**ADDENDUM NO. 1**

**MLK ELEMENTARY SCHOOL  
TRANSITIONAL KINDERGARTEN  
BAKERSFIELD CITY SCHOOL DISTRICT**

**Project No.: 5593  
DSA File No. 15-6  
DSA App No. 03-123900  
December 20, 2024**

Sheet No.: **A2.01**

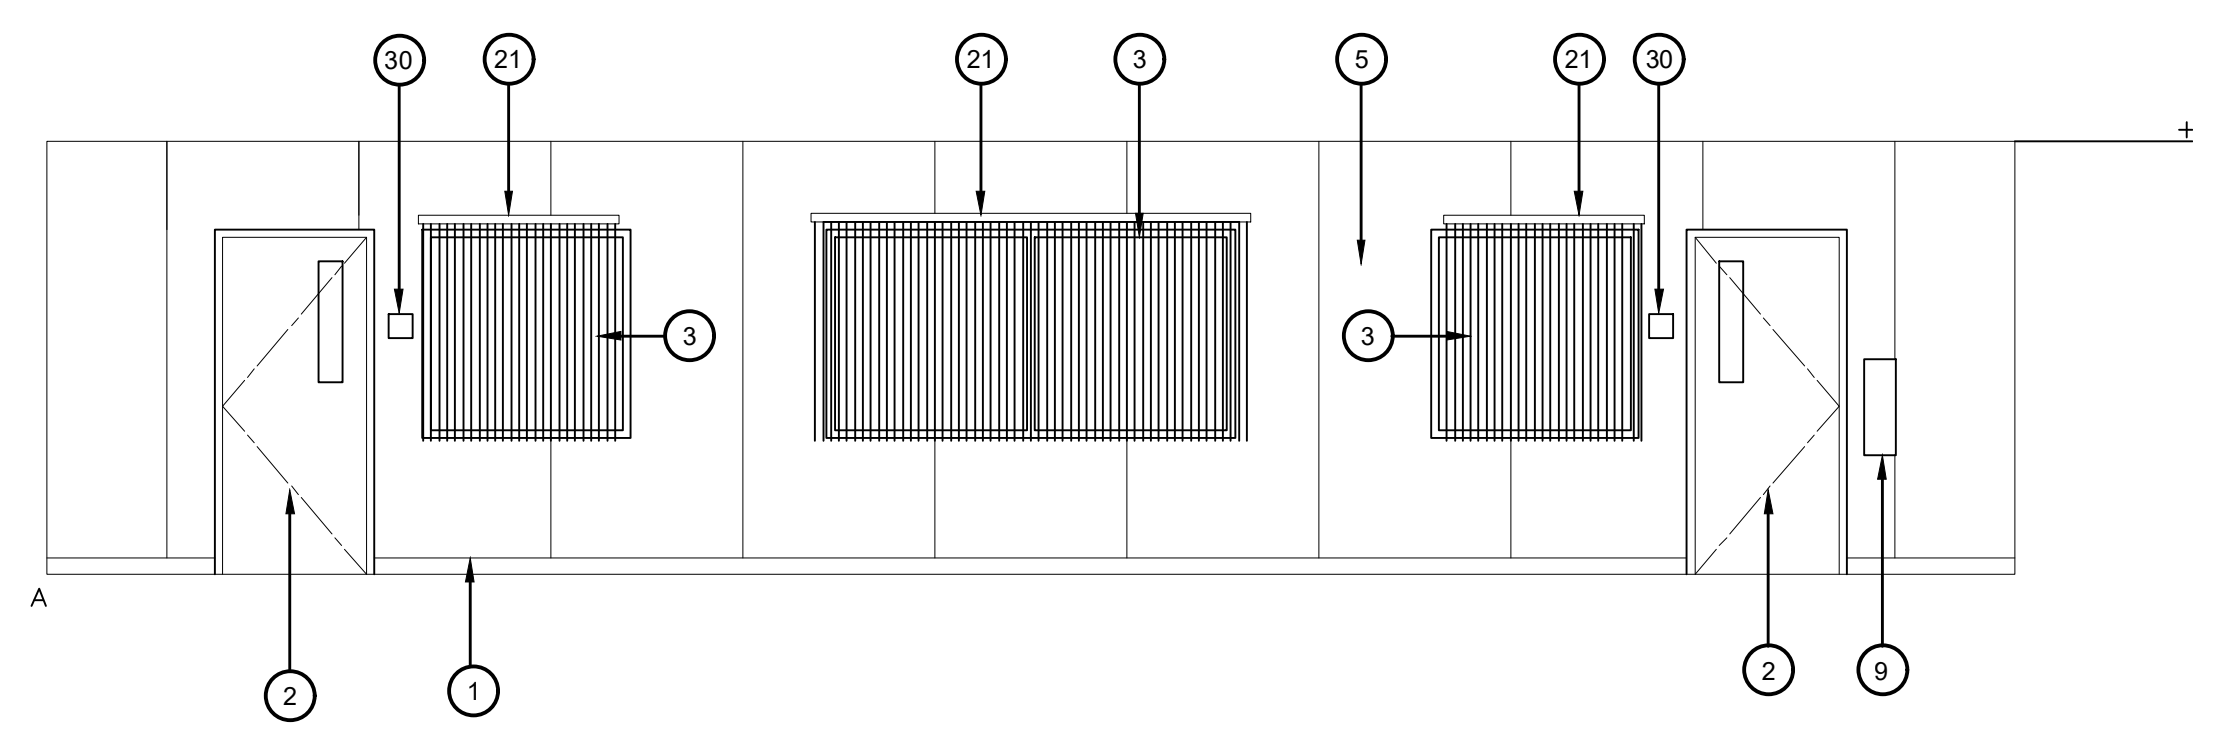
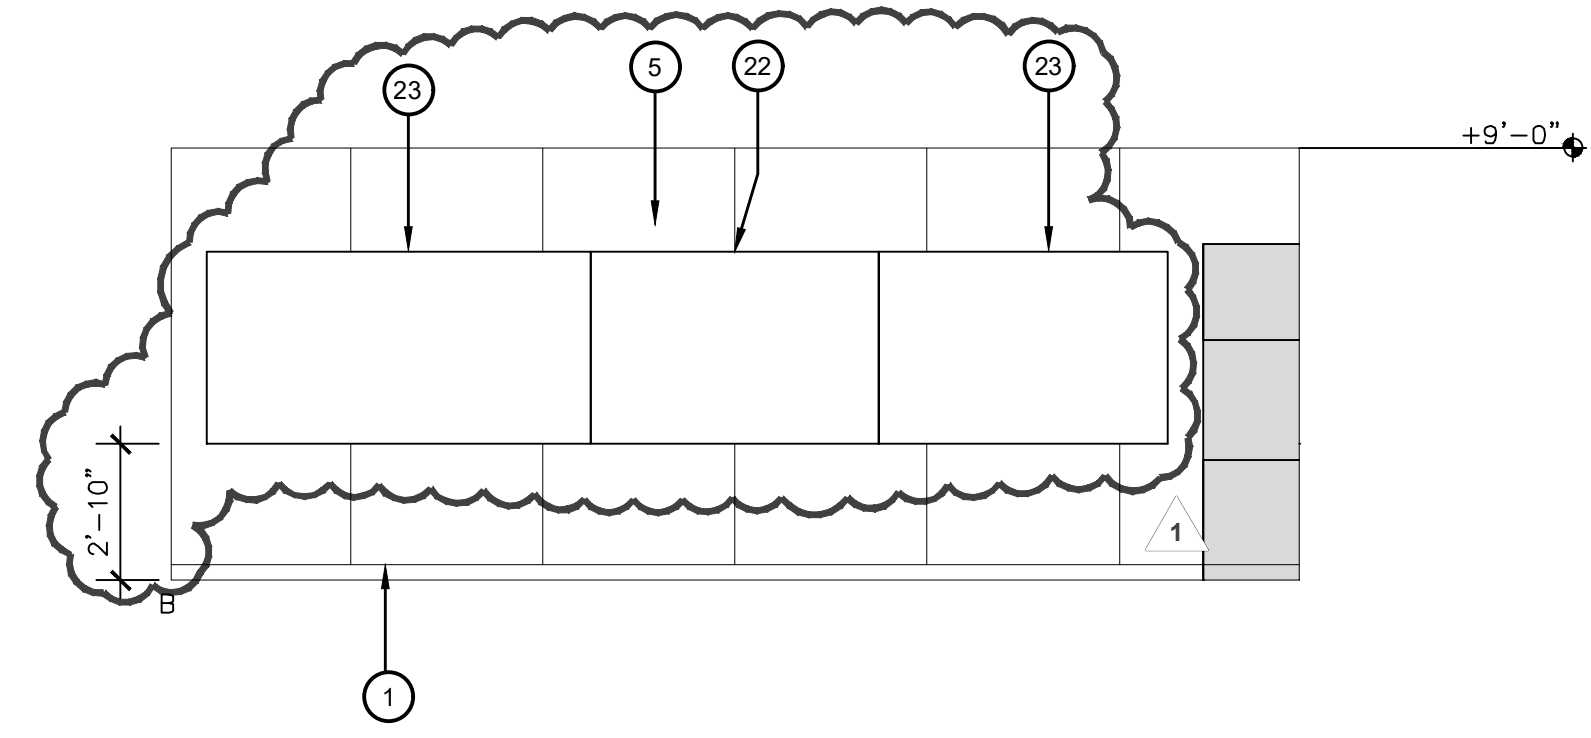
- 1-10 **DRAWING, SHEET A2.01 – FLOOR PLAN:** Note the following changes (See A2.01 addendum 1 drawing):
  - 1. Electrical and low voltage panels in room TK 2.1 have been changed. See keynotes 25 and 31 and Interior Elevations 5/A5.01
  - 2. Add IDF cabinet to room TK2.1. See keynote 31.
  - 3. Add tall cabinets to rooms TK1 and TK2. See keynote 30.
  - 4. Marker board and smart board have been moved to the East wall in room TK1 and TK2. See keynote 4 and 5.
  - 5. Add walk off carpet tiles to room 101. See keynote 27.
  - 6. VCT has been modified in TK1 and TK2. See keynote 10.
  - 7. Change markerboards to 5'-0" long. See keynote 24

8. Keynotes 1 and 9 have been modified.
